SUPPLEMENTAL INSTRUCTION

PROJ.: Turnbull School Music
Room Addition
PROJ. No.: 1705
DATE: January 31, 2019
S.I. No. S.I. - 010

Wall Sconces

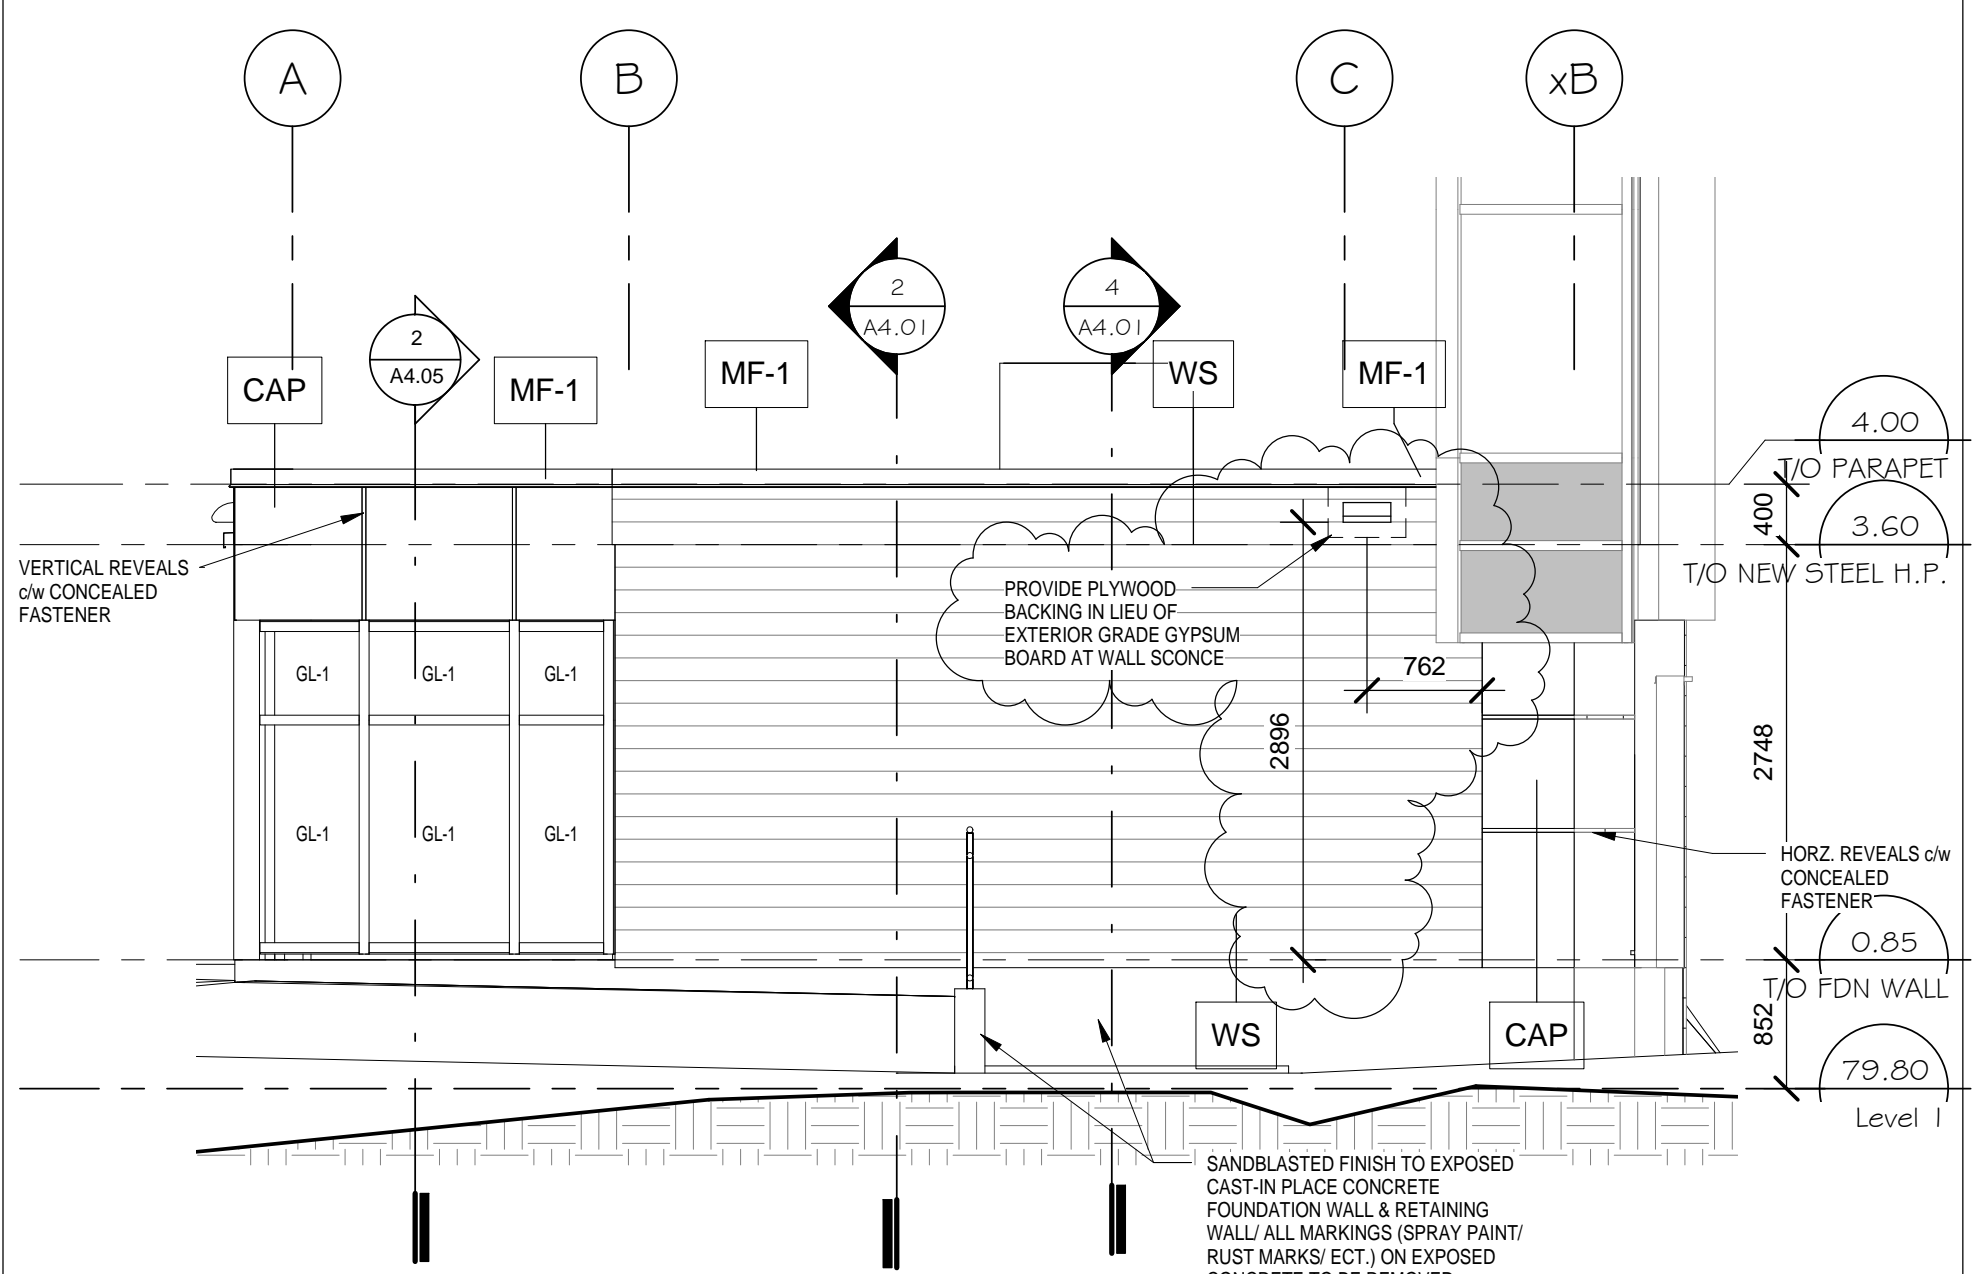
1. Refer to the attached Architectural Sketch SI-010.01 and SI-010.02 for revised elevations to clarify locations of the four (4) wall sconces. Provide plywood backing in lieu of exterior grade gypsum board at each wall sconce.
